# Balliemeanoch Pumped Storage Hydro

Volume 5: Appendices  
Appendix 4.2: Balliemeanoch Pumped  
Storage Hydro Scoping Opinion

**Scoping Opinion On Behalf Of Scottish Ministers Under The  
Electricity Works (Environmental Impact Assessment) (Scotland)  
Regulations 2017**

**Balliemeanoch Pumped Storage Hydro Scheme  
ILI (Borders PSH) Ltd**

**TITLE**  
Figure 1.2  
Above Ground Infrastructure

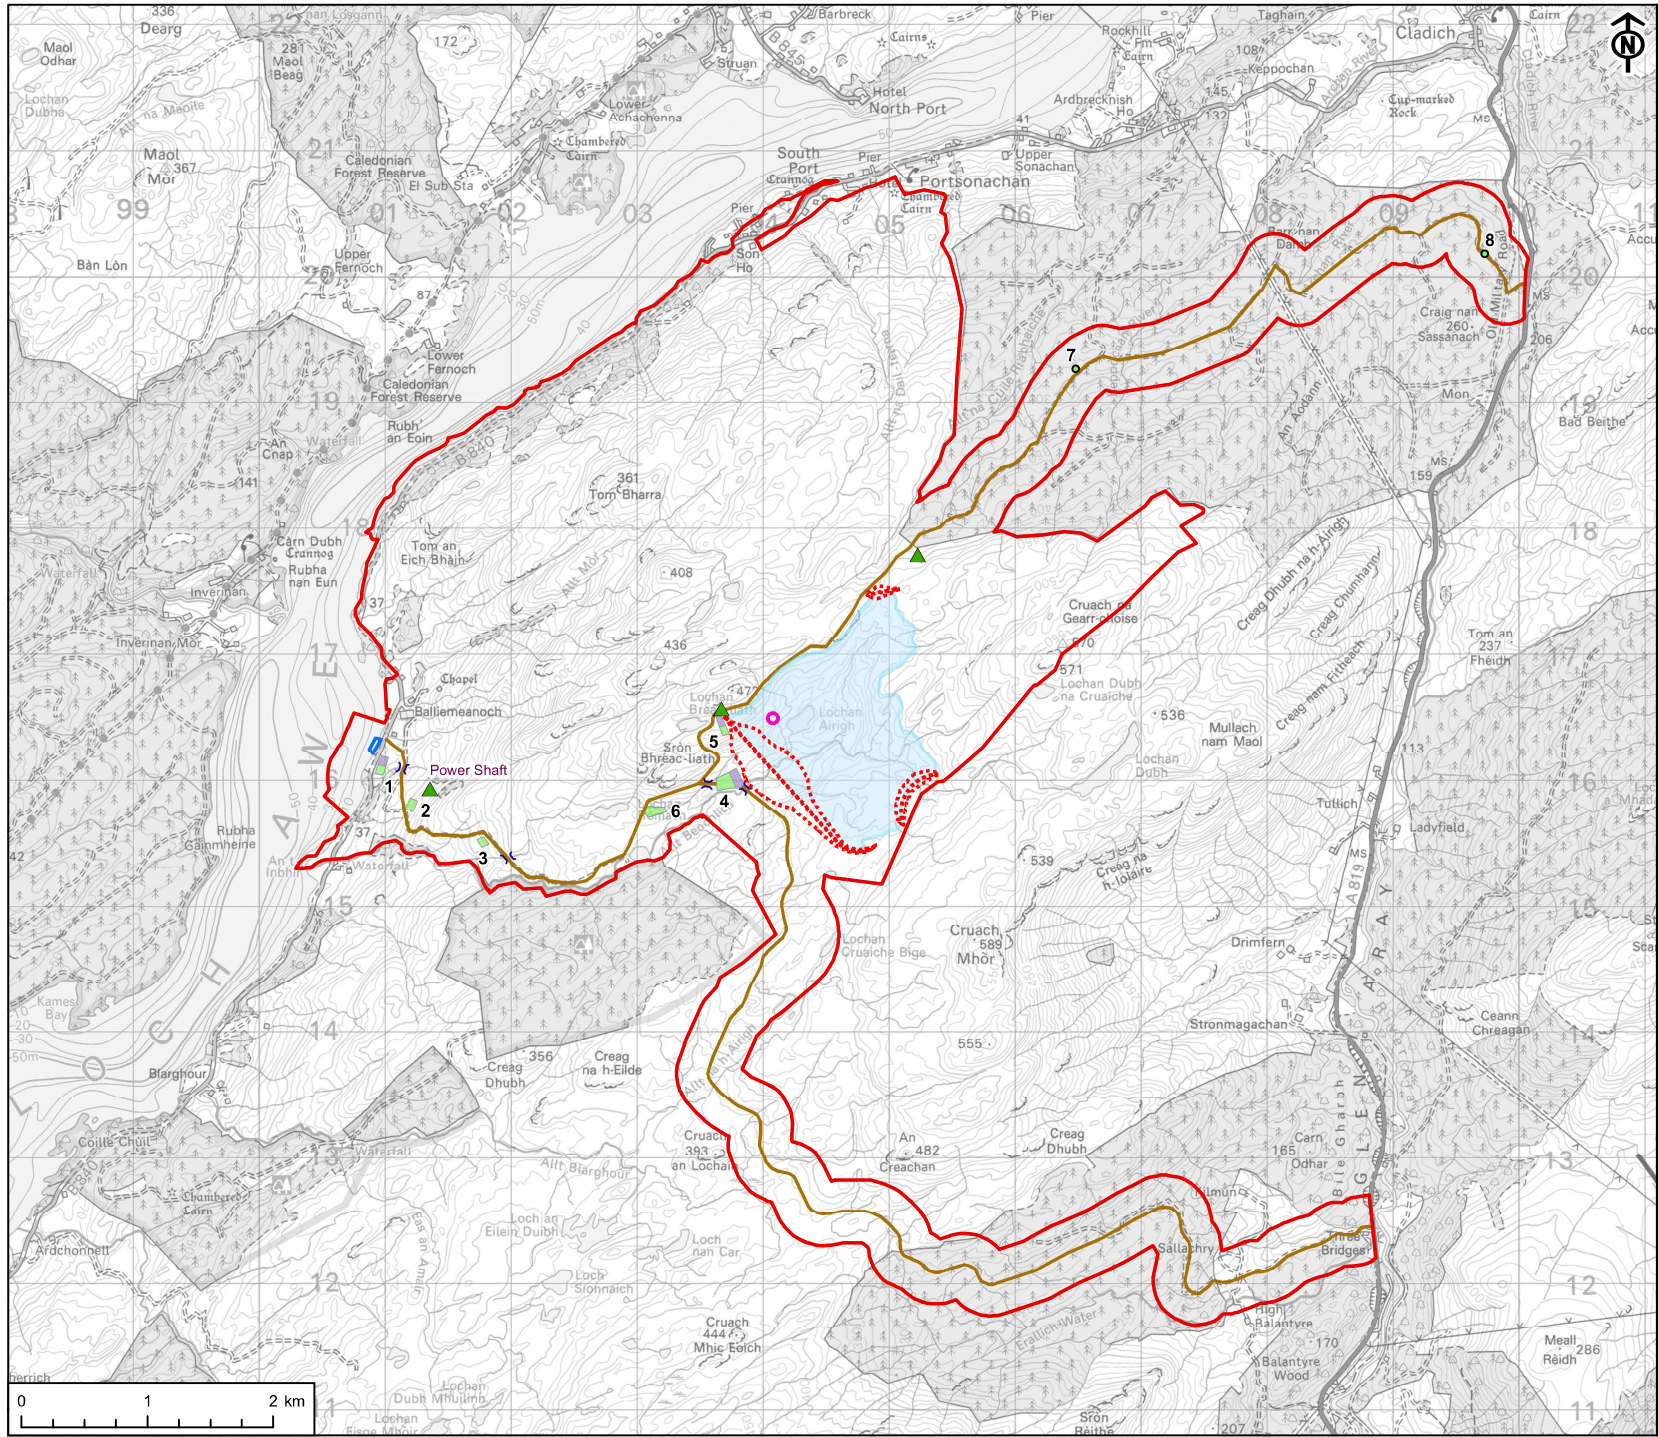
One of the access routes to Balliemeanoch Pumped Storage Hydro Scheme indicated on the plans submitted eg. on Figure 1.2 Above Ground Infrastructure (sheet 1) attached, incorrectly shows an access route over Blarghour Farm.
